Professional Snagging Inspection Report

Pre-completion inspection

Sample Development - Plot XX

Inspector: South Wales Snagging Co

Defect 3

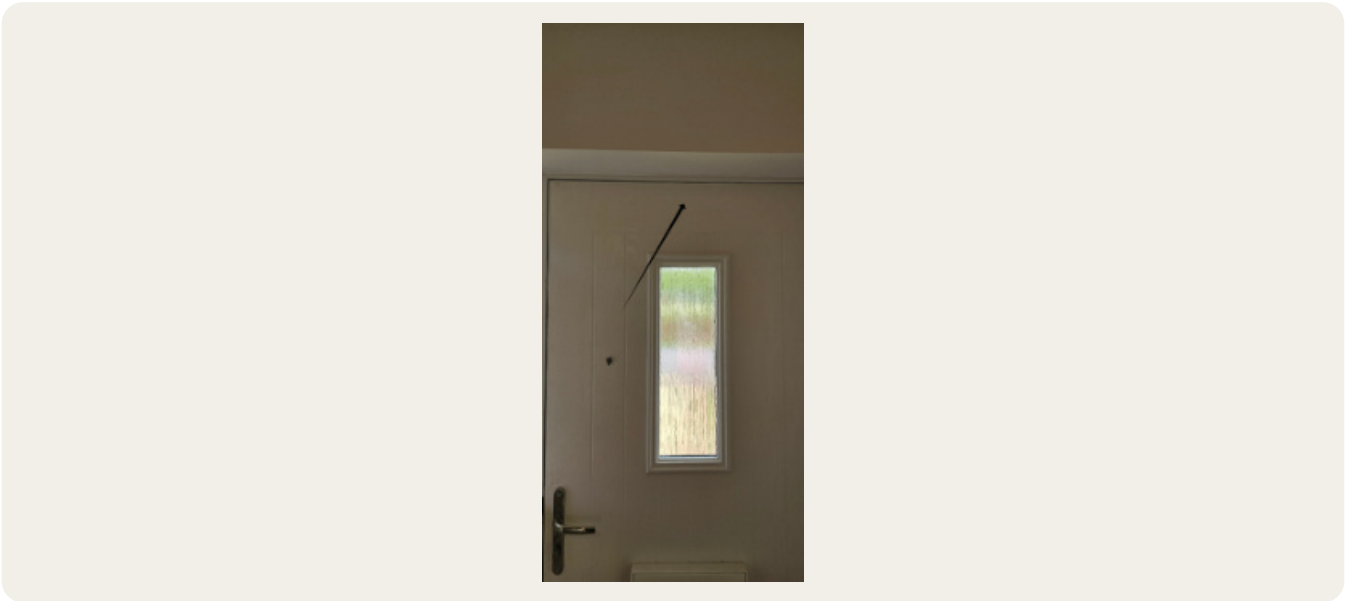
The margin at the head of the door is visibly uneven and reduced.

The developer should adjust the door or frame to achieve consistent margins.

Defect 6

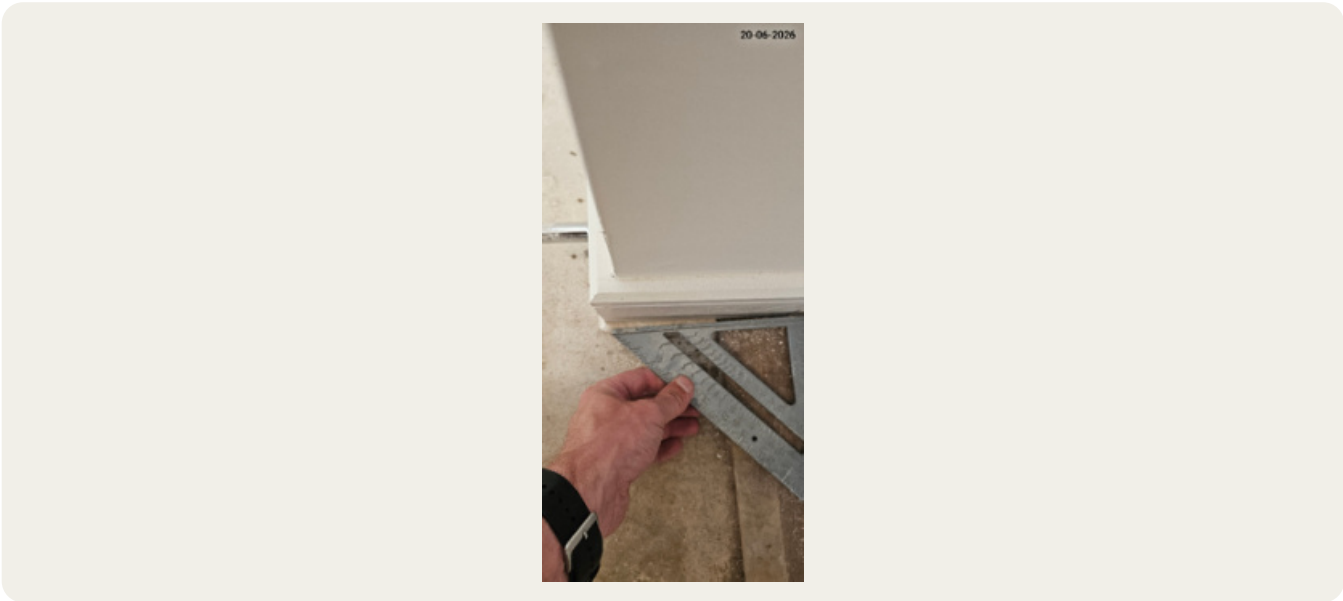
The front door reveal is more than 5mm out of square and the adjacent skirting requires adjustment.

The developer should make good the reveal and adjust the skirting so the finish is within acceptable tolerance.

Defect 8

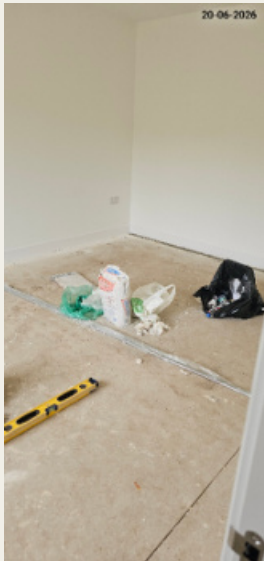
Access materials and construction debris remain within the property.

The developer should remove all access materials and construction debris and complete a final clean before handover.

Defect 12

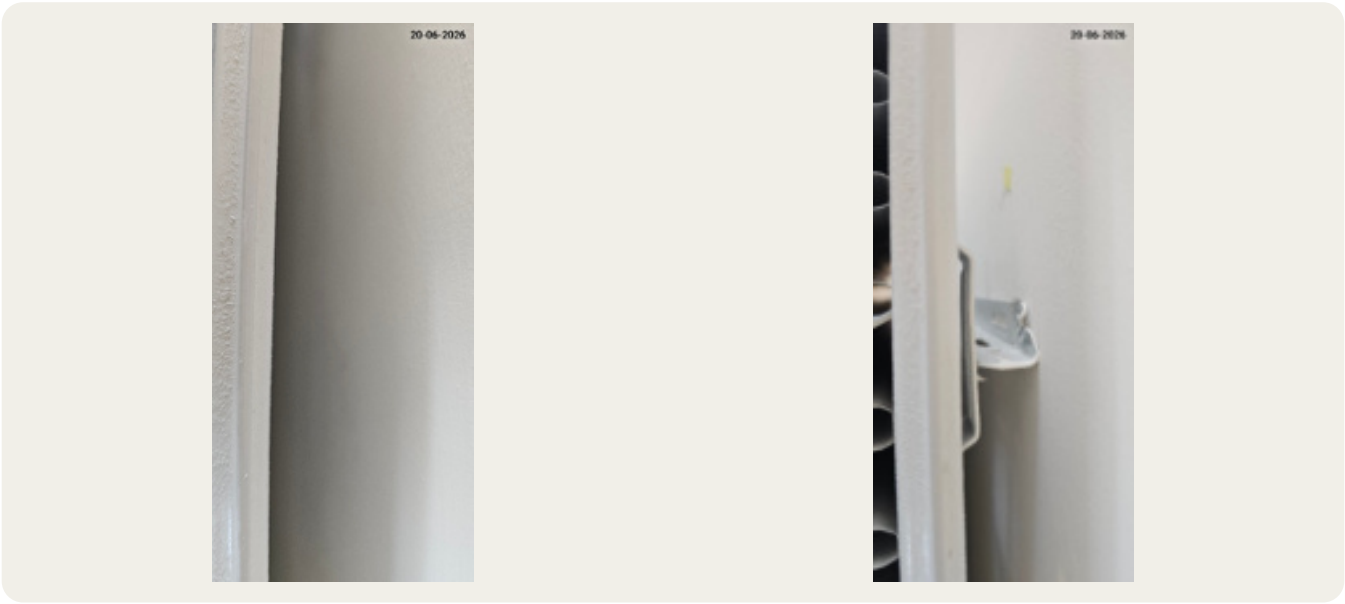
OBSERVATION
Decoration behind the radiator is incomplete, with pencil marks and paint contamination visible to adjacent brackets.

RECOMMENDED ACTION
The developer should complete decoration behind the radiator, remove pencil marks and clean paint from the radiator brackets.

Defect 14

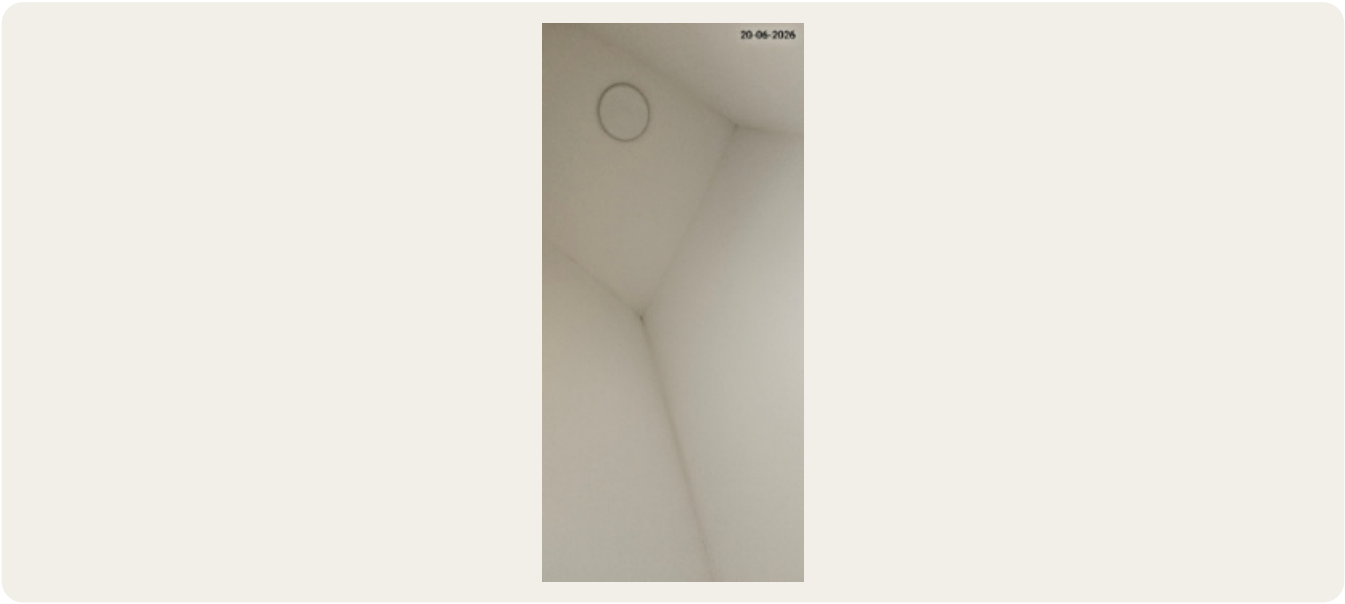
The ceiling finish is poor and requires making good.

The developer should make good the affected ceiling areas and redecorate to achieve a consistent finish.

Defect 16

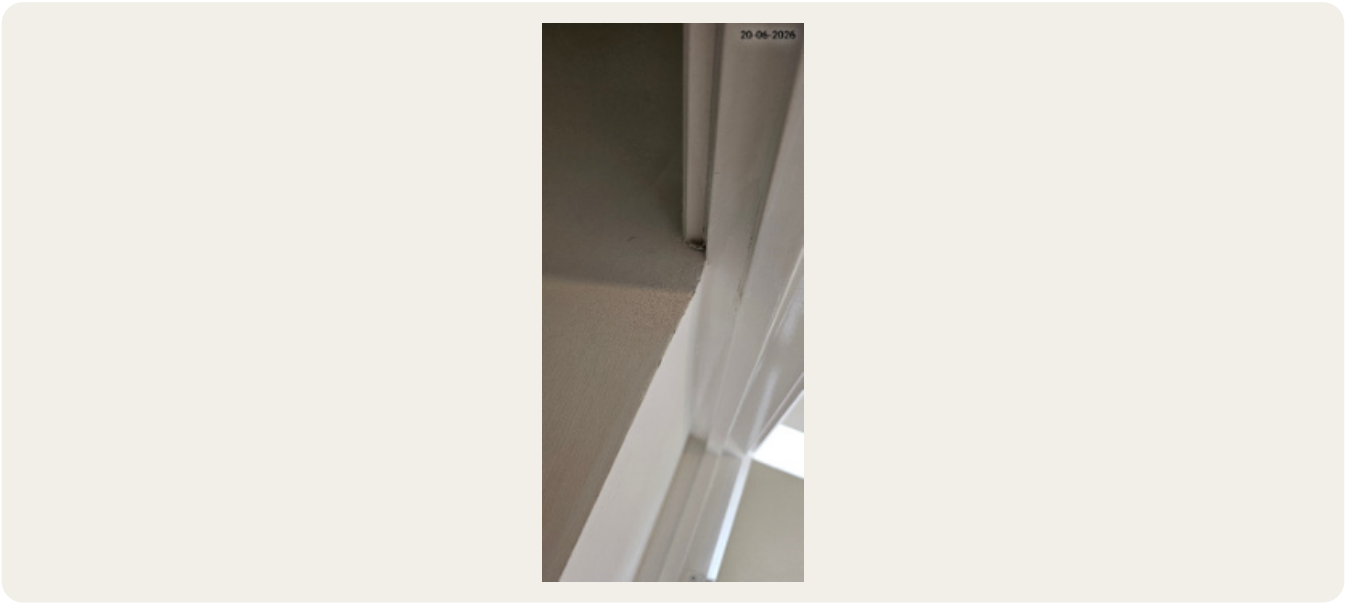
The finish to the head of the hallway cupboard architrave is poor.

The developer should make good and redecorate the affected architrave.

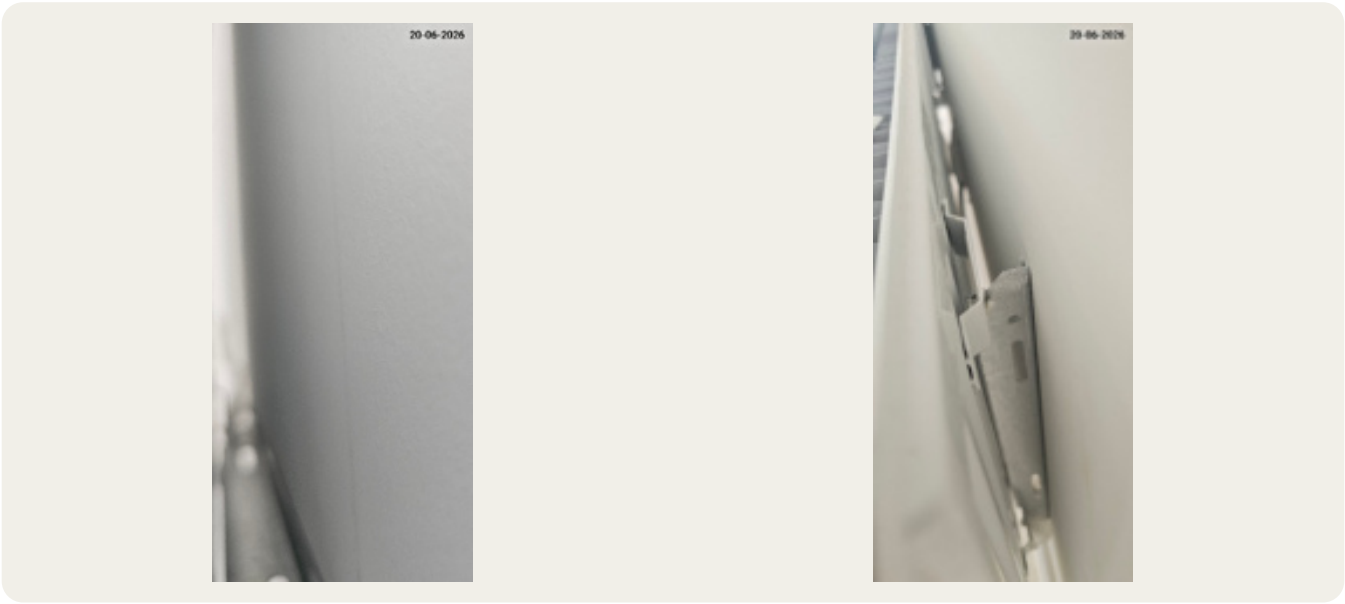
OBSERVATION
Decoration is incomplete behind the radiator.

RECOMMENDED ACTION
The developer should complete decoration behind the radiator and remove any pencil marks or paint contamination.

Defect 22

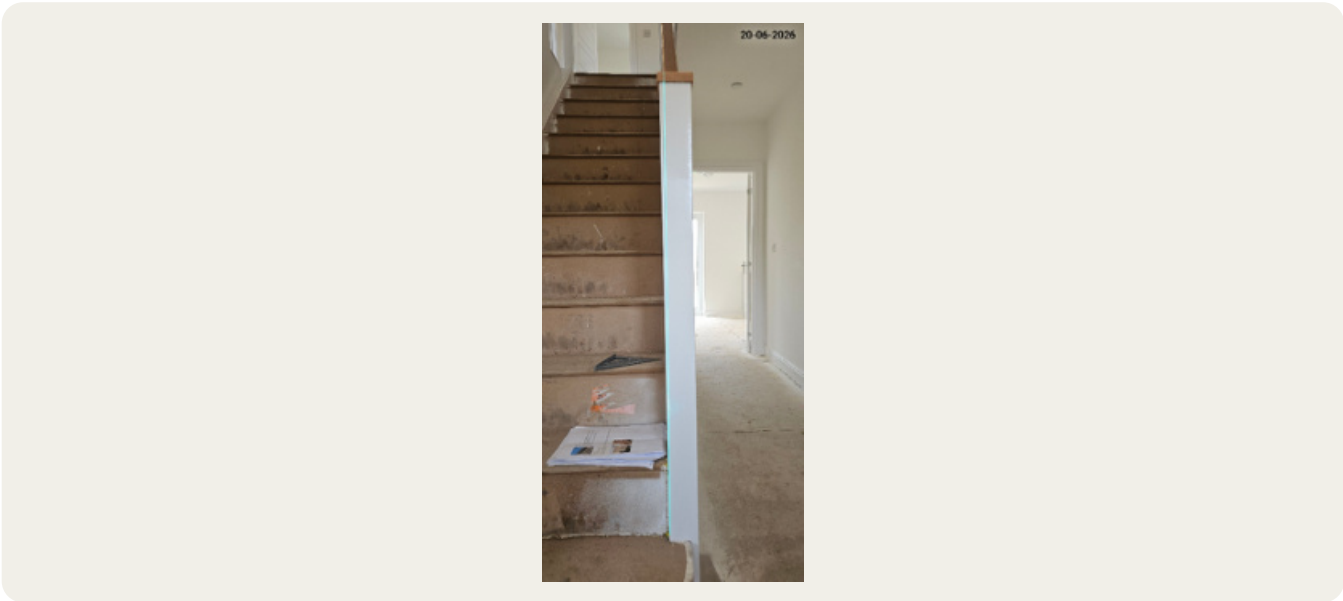
The newel post at the bottom of the stairs is out of plumb.

The developer should adjust and secure the newel post so that it is plumb.

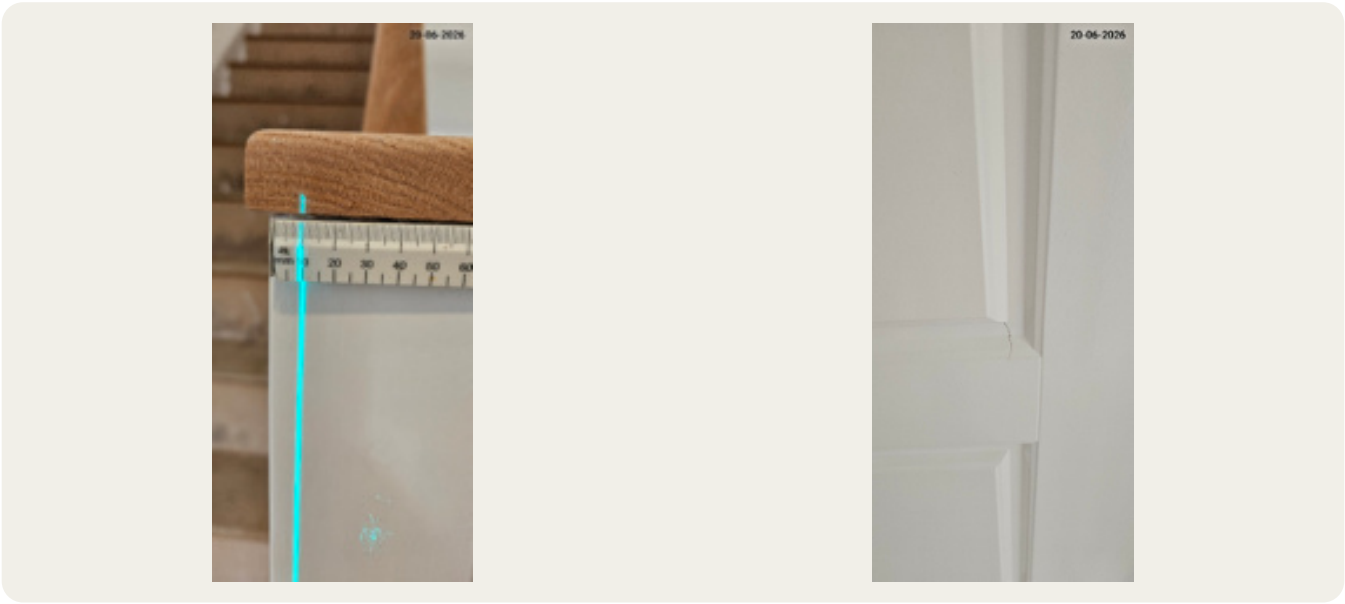
OBSERVATION
Damage is present to the WC door.

RECOMMENDED ACTION
The developer should repair the door or replace it if an acceptable finish cannot be achieved.

Defect 28

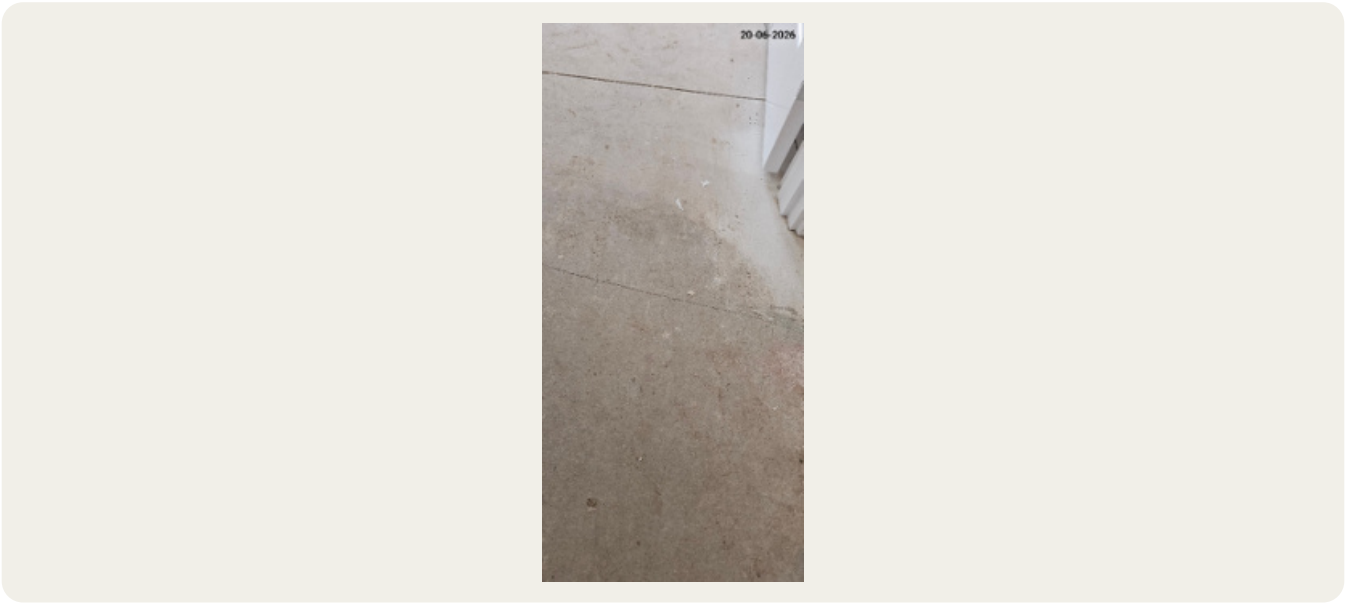
Issue 28: Hallway - Cracks and floor the hallway

This may affect the suitability of floor finishes, the performance of the completed floor and the homeowner acceptance of the property. Where cracking or significant level change is present, the developer should confirm the cause and appropriate remedial action.

The developer should review the cracking, complete suitable remedial works and provide written confirmation where technical review is required.

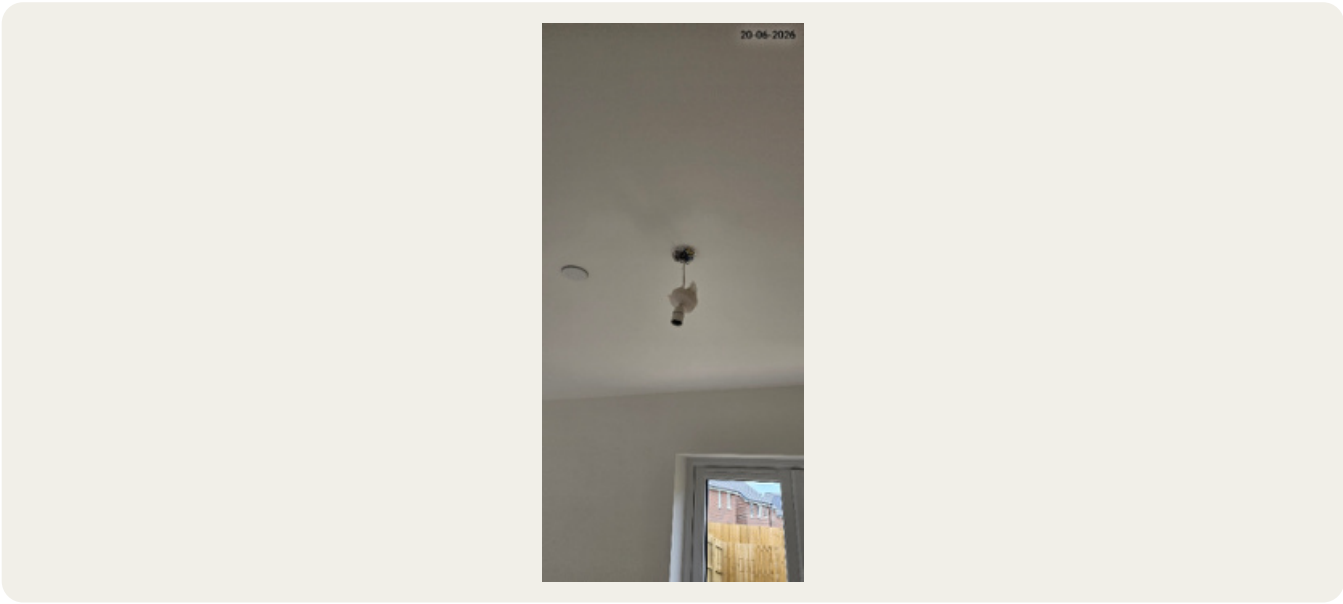
OBSERVATION
An electrical accessory or fitting issue was identified: Bulbs missing and ceiling roses not fitted.

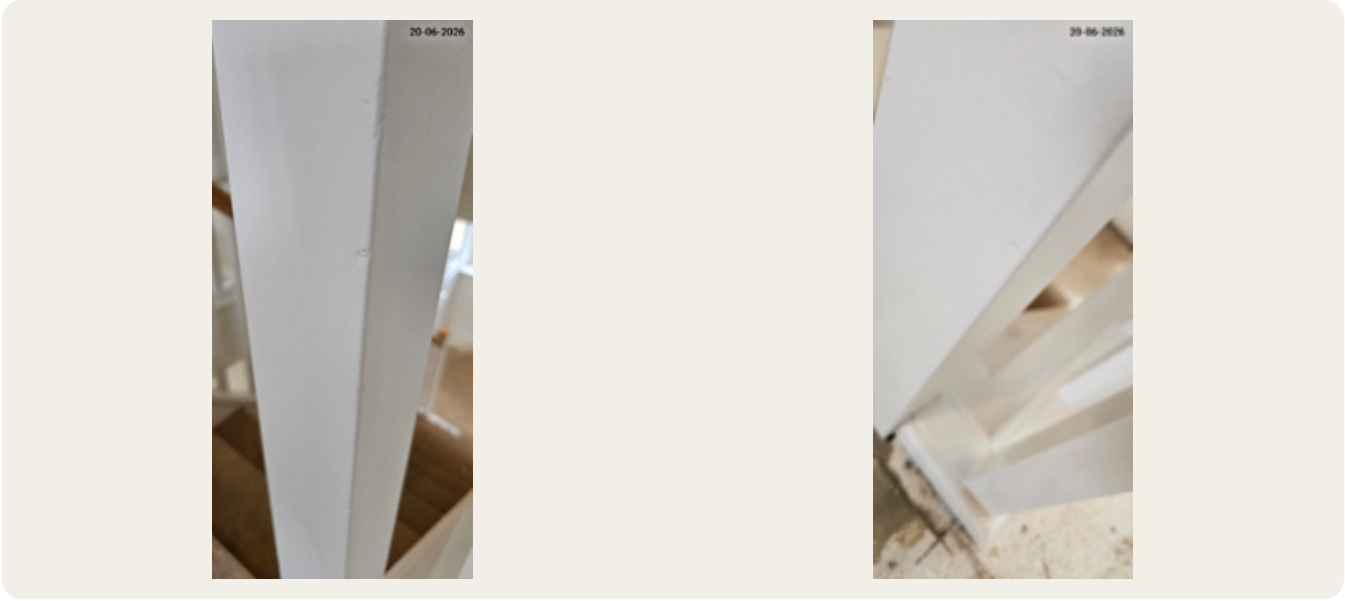
OBSERVATION
Damage is present to the newel post at the top of the stairs in several locations.

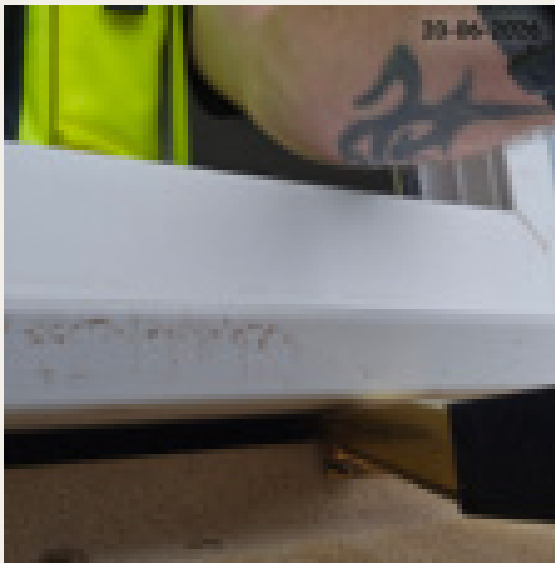
Issue 82: Bedroom 1 - Inadequate clearance beneath plastic sill to stone sill for differential settlement

The developer should provide appropriate clearance to allow for differential movement and prevent water tracking.

Defect 83

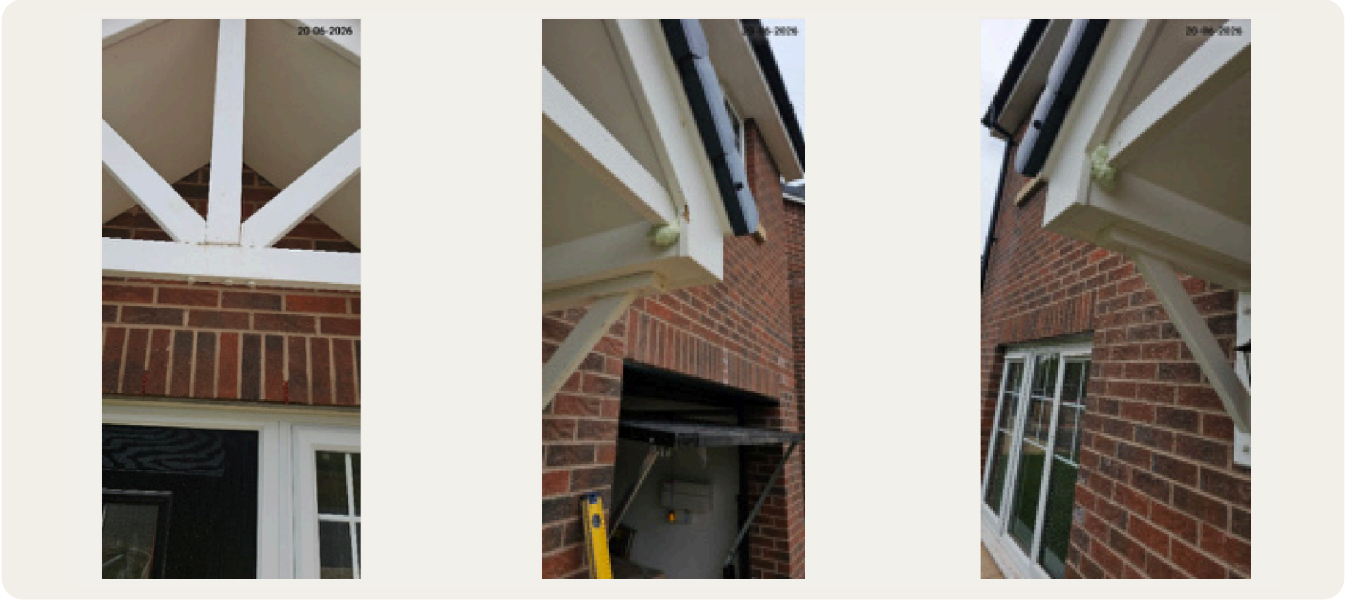
Issue 83: External - Damage to GRP canopy

The developer should replace the damaged GRP canopy or complete a manufacturer-approved repair.
